TLF35584

Multi Voltage Safety Micro Processor Supply

Errata Sheet

Rev. 3.0, 2017-03-17

Figure 1 Interrupted SYN output for activated spread spectrum (FRE pin to GND - LF)

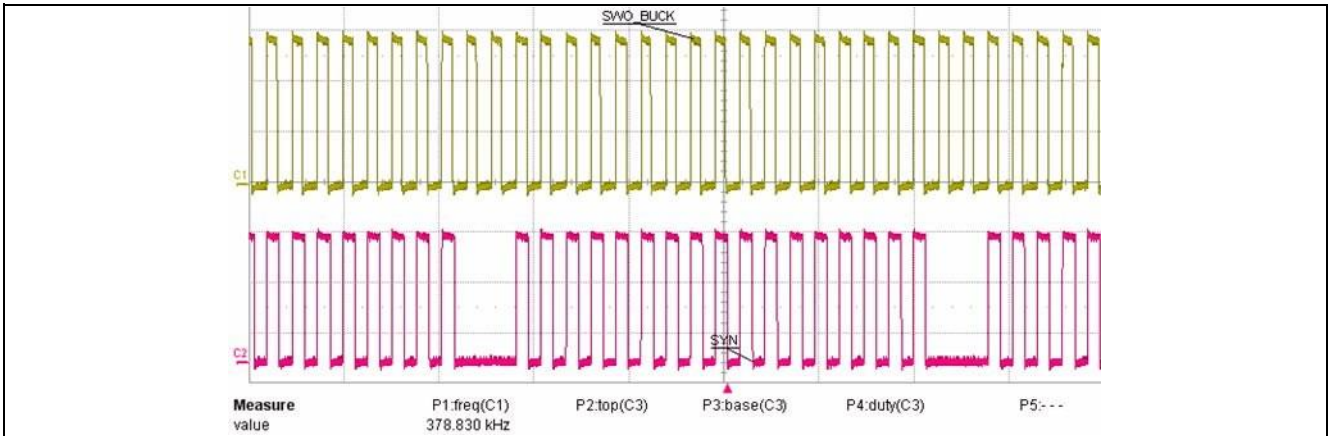
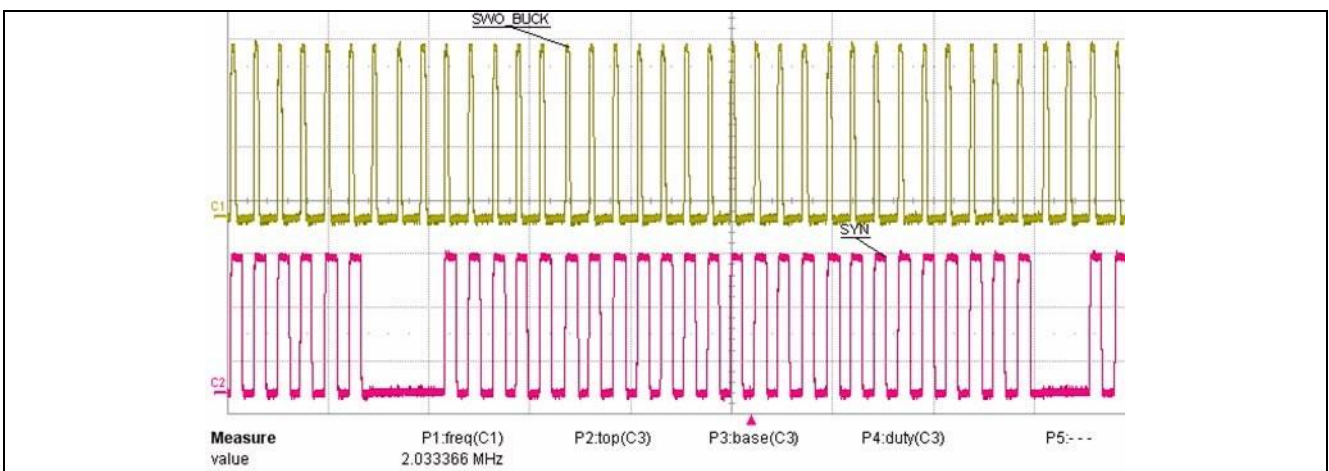
Number	Function	Description
1	Synchronization output signal with active spread spectrum	<ul style="list-style-type: none"> • There is a weakness of the C14-step silicon for the synchronization output signal for the optional core voltage regulator during activated spread spectrum. • In case the synchronization output SYN is being used and connected to an external switched mode power supply, it should be taken into consideration that the SYN-output signal might be interrupted unintentionally in a randomic way for activated spread spectrum. • In Figure 1 and Figure 2 it is shown how the signal of SYN might look like. The figures have been generated using the synchronization without phase shift (DEVCFG2.ESYNPHA = 0). For this configuration the SYN output signal will stuck to low signal temporarily. For configuration with 180° phase shift (DEVCFG2.ESYNPHA = 1) the stuck signal would be high level.

Figure 3 Reset Output (ROT) weakness - Example: Short to GND detection of QUC

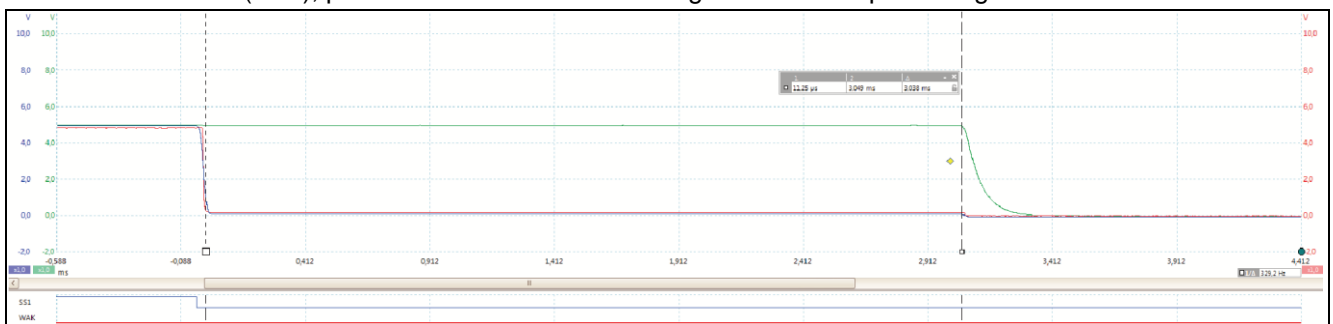
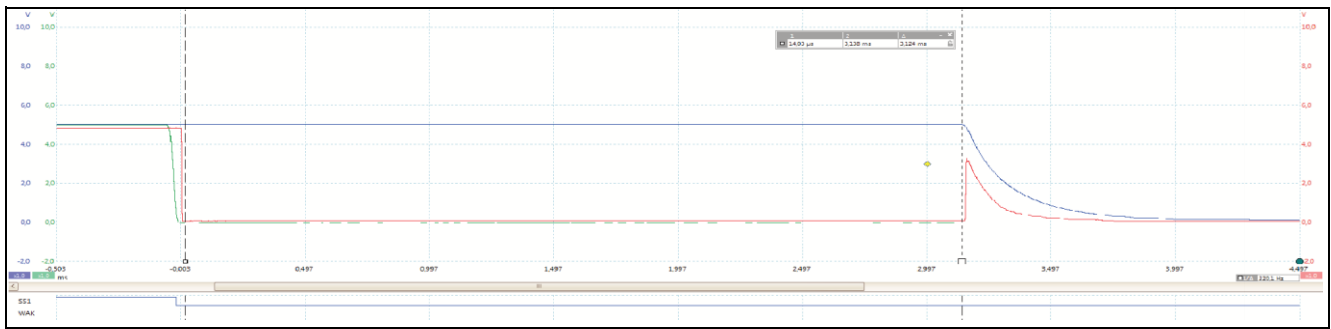
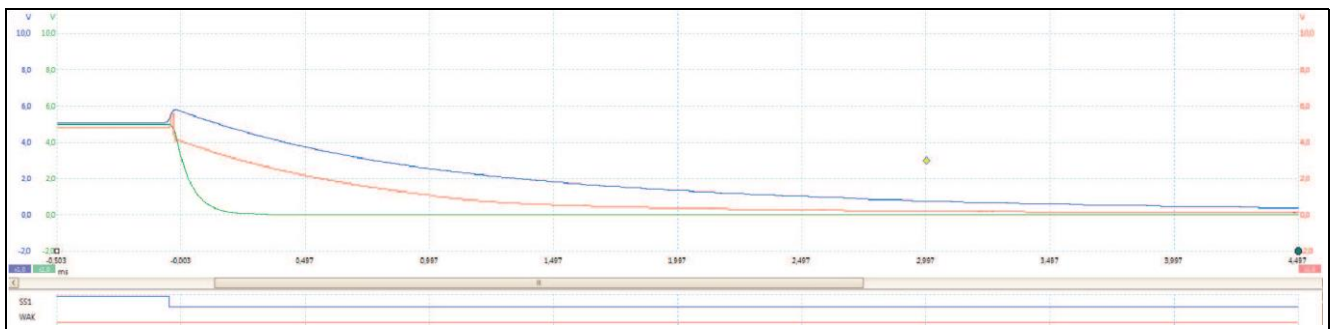
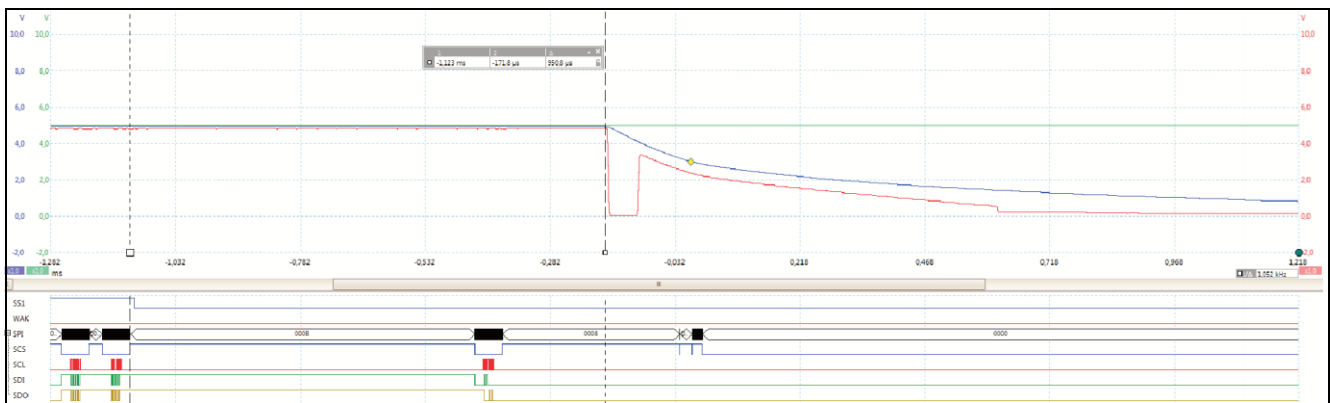
Number	Function	Description
1	Reset output ROT behavior in Move-toFAILSAFE conditions	<ul style="list-style-type: none"> • There is a weakness of the C14-step silicon related to the reset output pin ROT, in case the TLF35584 moves to FAILSAFE state. In a safety context the reset function and the reset output ROT is considered to be QM, accordingly safety is not affected. • The output driver of the open drain transistor in the reset output ROT is disabled together with the microcontroller supply Ido (QUC). According to the fact that the QUC is disabled/switched off in case of a Move-toFAILSAFE event, the reset output is not longer pulled to low signal and is pulled up to QUC. As the QUC is disabled and the output cap is discharged by the load and an internal active pull-down of ~80 Ω, this is reflected in a transient behavior which is shown in the figures below. The observation and relevance strongly depends on the failure case and its boundary conditions. These conditions are elaborated in the following list. <ul style="list-style-type: none"> – QUC shorted to GND: The voltage monitoring detects the UV and pulls down ROT. SS1/2 are going low and application is in safe state. QUC is shorted to GND and has 0V accordingly, but provides current (still enabled). After typ. 3ms TLF35584 moves to FAILSAFE state and disables the Ido and resets the output driver of ROT. Due to the short to GND ROT stays low as it is pulled to QUC. (no problem) Please refer to Figure 3. – QUC overloaded by current. The voltage monitoring detects the UV due to the decreased output voltage by current limitation or dropout voltage (only without boost) and pulls down ROT. SS1/2 are going low and application is in safe state. Due to the assertion of ROT the microcontroller is switched off and decreases its current consumption dramatically. The output voltage of QUC might recover into valid voltage range and the TLF35584 restarts in INIT state. (no problem) – Continuous UV or short to GND on QST or VCI: The voltage monitoring detects the UV on the respective rail and pulls down ROT. SS1/2 are going low and application is in safe state. QUC continuous to regulate to its nominal output voltage. After typ. 3ms TLF35584 moves to FAILSAFE state and disables all Ido and resets the output driver of ROT. The reset output might be pulled up to the discharging QUC (by the attached load and an active pull-down of ~80 Ω). This might result into a temporary high level at ROT during the shutdown transition. A undervoltage monitoring of the microcontroller could prevent undesired start of the microcontroller operation. Please refer to Figure 4. – Continued on the next page.

Number	Function	Description
1 (cont'd)	Reset output ROT behavior in Move-toFAILSAFE conditions (cont'd)	<ul style="list-style-type: none"> Continued: <ul style="list-style-type: none"> QUC shorted to an higher voltage rail: The voltage monitoring detects the OV on the QUC rail and SS1/2 are going low and application is in safe state. TLF35584 will move to FAILSAFE which is disabling QUC as well as all other regulators and activates the active pull-down of ~80 Ω on QUC output, trying to discharge the rail. The FAILSAFE state disables also the output driver of ROT. The reset output might be pulled up to QUC. This might result into a high level at ROT during presence of the external overvoltage. Still the application will be safely shutted down during in this case by SS1/2. Please refer to Figure 5.
2	Reset output ROT behavior for Move-toSTANDBY transitions	<ul style="list-style-type: none"> There is a weakness of the C14-step silicon related to the reset output pin ROT, in case the TLF35584 moves to STANDBY state. In a safety context the reset function and the reset output ROT is considered to be QM, accordingly safety is not affected. The output driver of the open drain transistor in the reset output ROT is disabled shortly after the microcontroller supply Ido (QUC). According to the fact that the QUC is disabled/switched off at the point in time when the device enters into STANDBY state (transition delay time expired or in case of QUC current monitoring usage after a decrease below the current threshold), the reset output shortly pulled to low, but pulled up to the output voltage of QUC right after. Nevertheless the output of QUC is actively discharged by the load and an internal active pull-down of ~80 Ω, this is reflected in a transient behavior which is shown in Figure 6 below.

Figure 7 Interrupted state transition NORMAL-STANDBY (MPS pin set low)

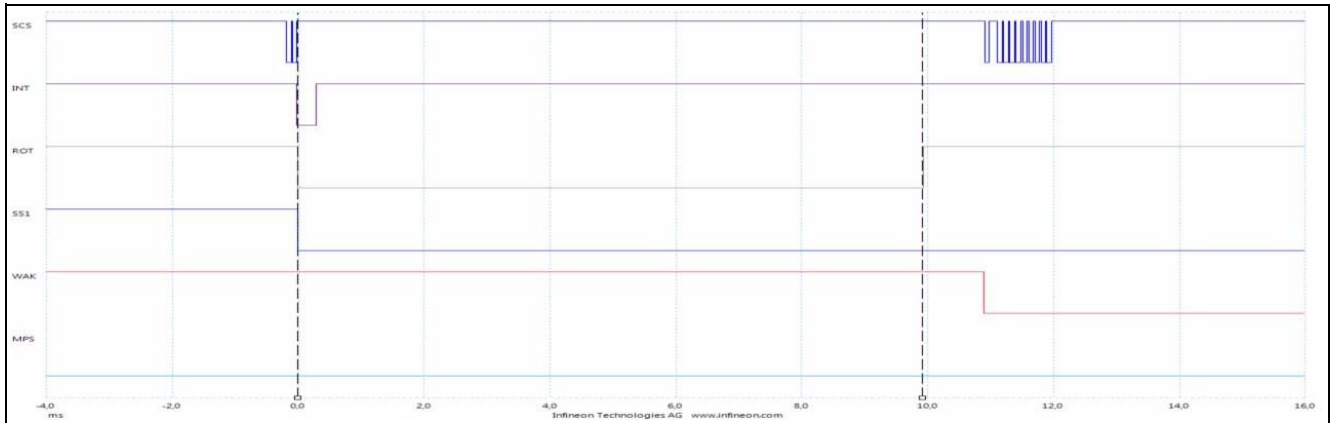
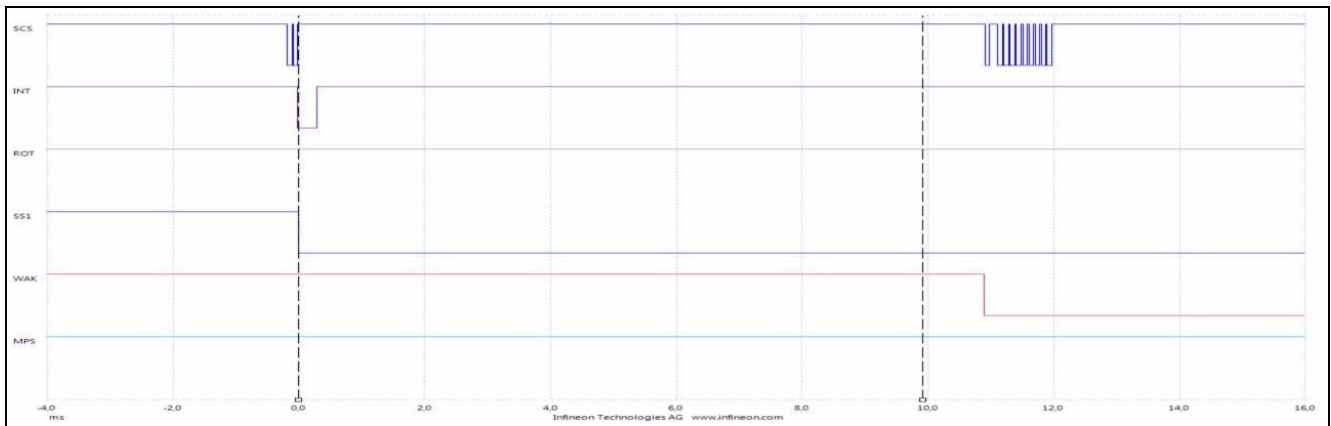
Number	Function	Description
9	Microcontroller programming support (MPS) influence to state transition NORMAL/WAKE to STANDBY	<ul style="list-style-type: none"> • The chapter 11.7 in the Data Sheet Rev 2.0 describes influences to the overall device behavior of the TLF35584. Beside the described differences there is a unintended influences to the device behavior in case of microcontroller programming support being active (MPS-Pin high) for the movement NORMAL/WAKE to STANDBY. <ul style="list-style-type: none"> – For the particular case of an interrupted state transition from NORMAL/WAKE to STANDBY due to a wake-up event by WAK (level) or ENA(edge) during the transition, the TLF35584 is not triggering ROT to low when moving to INIT state. Accordingly the behavior with and without MPS being activated can be compared by Figure 7 and Figure 8. Nevertheless the interrupted transition is triggering in both cases an interrupt event and reports the interrupted state transition by the interrupt register IF.SYS and the subsequent diagnostic register SYSSF.TRFAIL.
